## **CandCNC Tech Support**

### **IMPORTANT FIELD MODIFICATION of THC SENSOR CARD FOR ALL MP3000-DTHC and BLADERUNNER DRAGON-CUT UNITS.**

## IMPORTANT MODIFICATION FOR ALL THC SENSOR CARDS

**BOTTOM VIEW  
NOT ALL RUNS  
SHOWN**

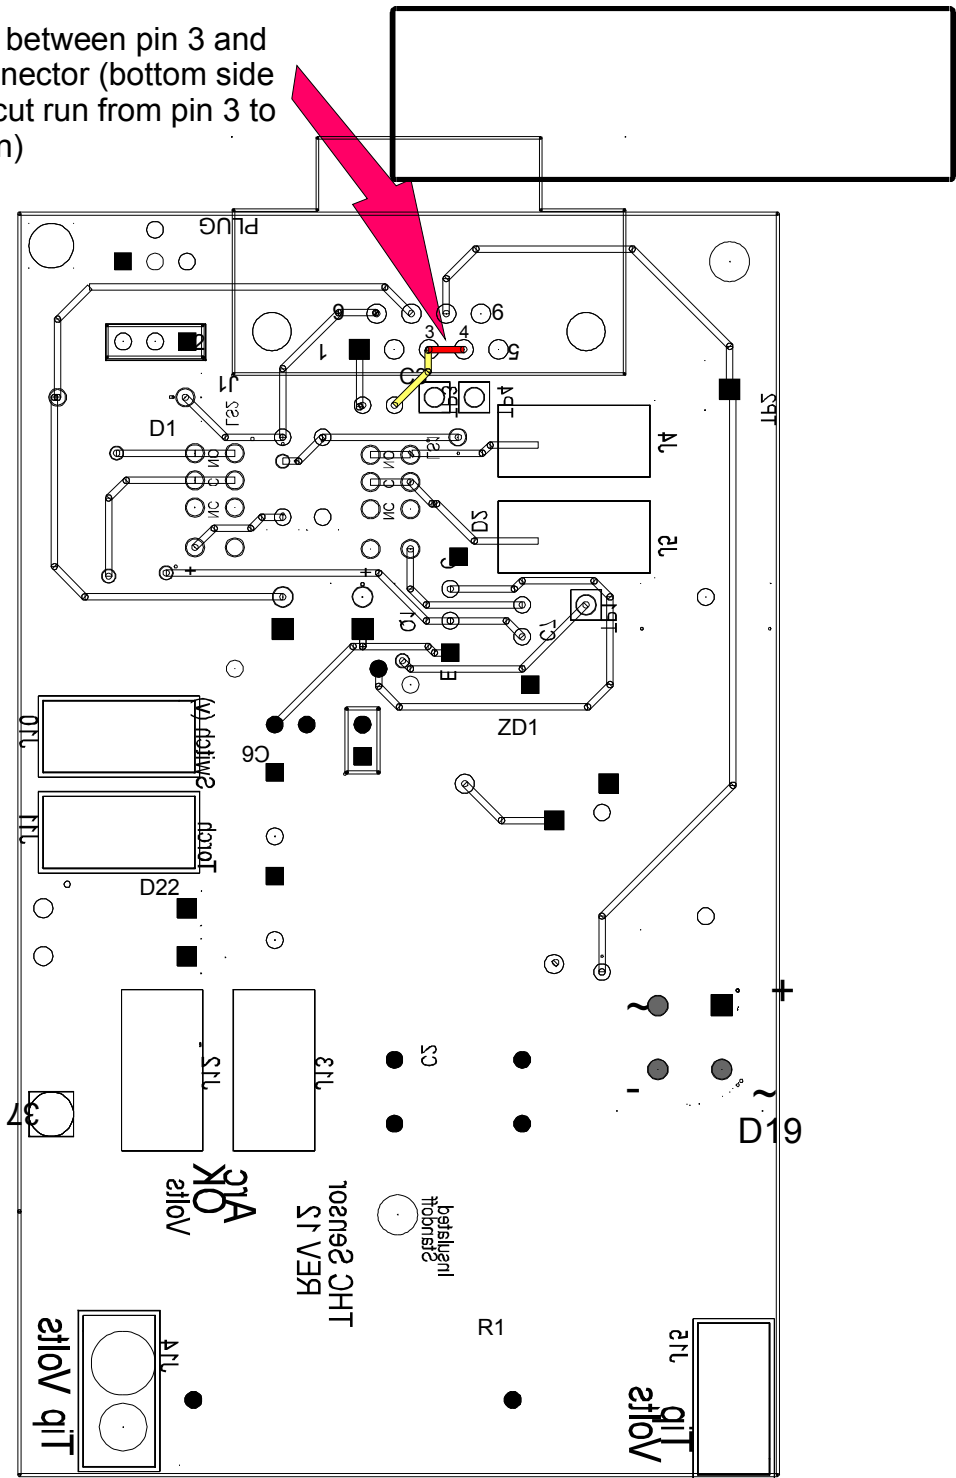
Cut this (red) run between pin 3 and 4 on the Db9 connector (bottom side of card) Do **not** cut run from pin 3 to C3 pin.(yellow run)

Bottom of THC SENSOR Card (REV12) view. Turn card over and locate pins 3 and 4 on the Db9. There is a small board run (connection) between pins 3 & 4. It must be cut/removed. Cut it with a sharp object. After the cut, test for continuity (ohmmeter or continuity tester) to make sure the connection is broken. There should be NO Connection (infinite resistance). DO NOT CUT ANY OTHER RUNS. See the next page for possible re-calibration steps if needed.

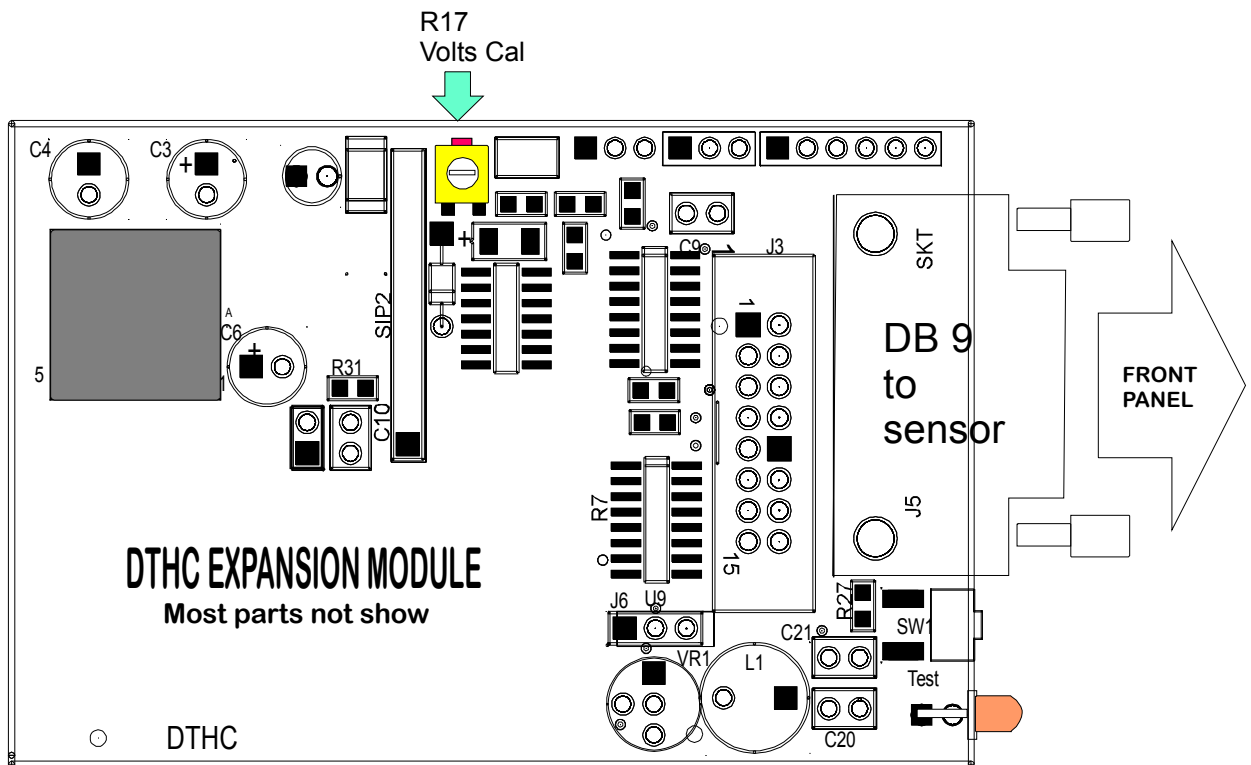
**IMPORTANT: DO NOT RE-CALIBRATE YOUR DTHC UNLESS YOU HAVE DONE THE MODIFICATION ON THE THC SENSOR CARD LISTED AND YOU OBSERVE THAT THE VOLTAGE WHEN RUNNING APPEARS TO BE ABOUT 10% LOW. SOME UNITS MAY NOT NEED TO BE RECALIBRATED. NORMAL FACTORY CALIBRATION SHOULD NOT BE CHANGED FOR ANY OTHER REASON**

DTHC Card is located inside MP3000-DTHC and Dragon Cut behind front panel, and held in place by the two jack screws through the front panel to the DB9. You should be able to access R17 adjust pot without removing the card from the front panel. The Volts calibration is done with the THC Sensor TIP VOLTS inputs connected to a source of known DC voltage. **It's more accurate to use at least 48VDC.** Use a DVM to monitor the actual DC test volts (at the TIP VOLTS Terminals). The proper profile for MACH should be loaded and the screen will display the TORCH VOLTS reading. With a small screwdriver adjust R17 until the reading in MACH matches the actual test voltage applied. It should not take a large amount of change to bring the unit into calibration.

IF YOU DO NOT WANT TO ATTEMPT RE-CALIBRATION OF YOUR DTHC THEN PULL THE MODULE LOOSE FROM THE FRONT, DISCONNECT THE 16 PIN INTERFACE CABLE AND RETURN THE CARD TO US.

# CALIBRATION SCHEMATIC

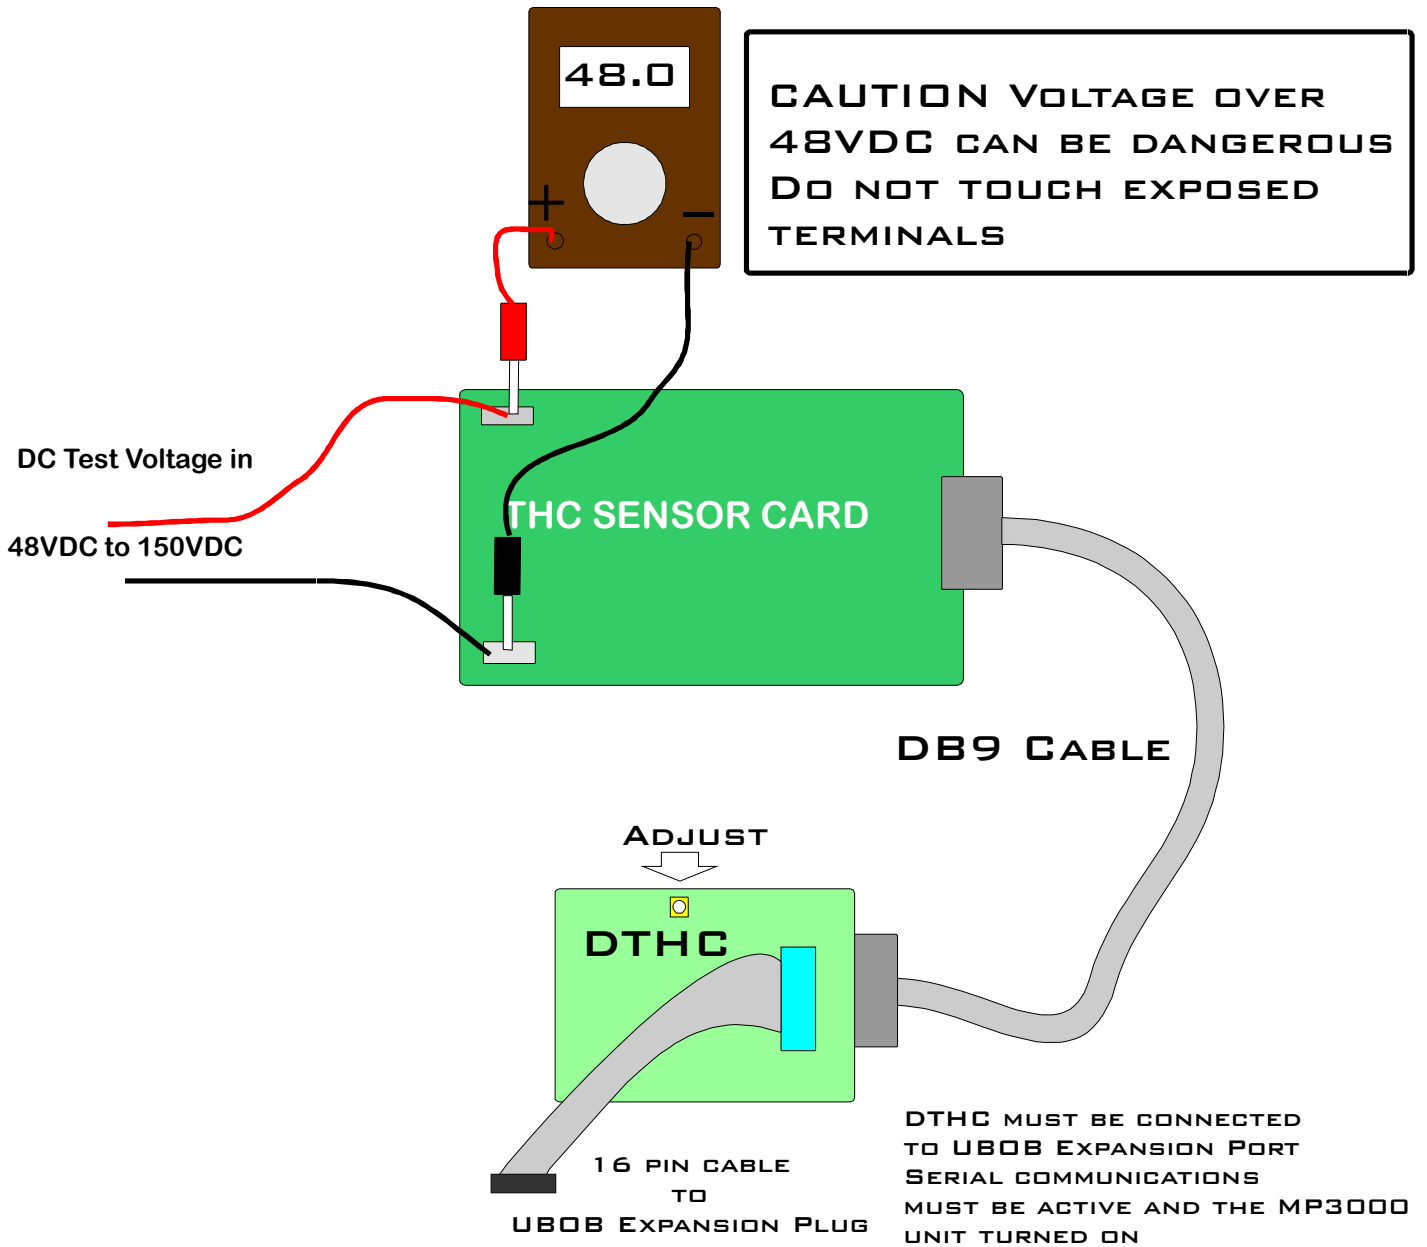
SET TORCH VOLTS = TEST VOLTAGE READOUT
